The Glitch & The Fix: February 2007

You Can't Make This Stuff Up

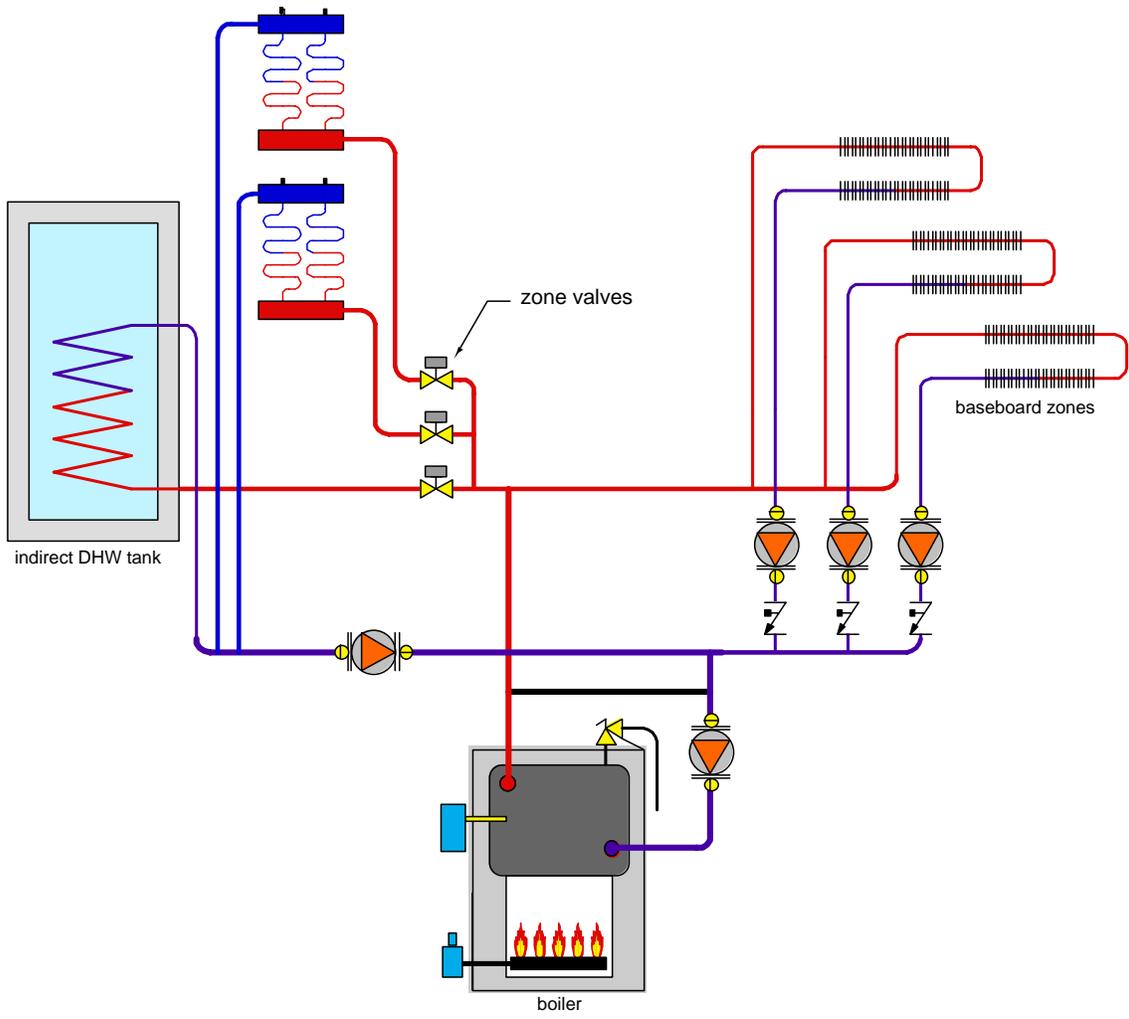
My speculation is that this system uses higher temperature plateless staple radiant floor heating along with three zones of baseboard.

Although I can only speculate on the design intent, this system contains several piping details that should be avoided.

1. If the intent of the boiler bypass was to prevent sustained flue gas condensation the installer will discover this doesn't work. The only assured way of preventing sustained flue gas condensation is to measure boiler inlet temperature and partially restrict hot water flow to low temperature load when necessary. If we assume all the loads including the radiant panel circuits are high temperature loads there really is no need for the bypass.

2. The "bullhead tee" at the top of the main boiler supply pipe is not a good detail. The turbulence it creates causes significant head loss as well as flow noise.

3. The zone circulators and flow checks should be located on the supply size of the zones to minimize heat migration. Since no expansion tank is shown there is no way of knowing whether the circulators are attempting to "suck" rather than push flow through the zone circuits.

4. My preference would be to use a zone circulator rather than zone valve for the indirect water heater. This will result in higher coil flow rates and higher rates of heat transfer. I would also suggest operating the indirect water heater as a priority load.

5. When zone valves are used in combination with a fixed speed circulator a differential pressure bypass valve should be used.
6. Apparently the designer didn't see a need to install an air separator or purging valves. I have no clue how he expects to get the water in or the air out at start-up. I would certainly recommend a make-up water system, central air separator, and purging valves.

7. Indirect water heaters with vertical coils should be piped for counterflow heat transfer (hot water supplied to top of coil).
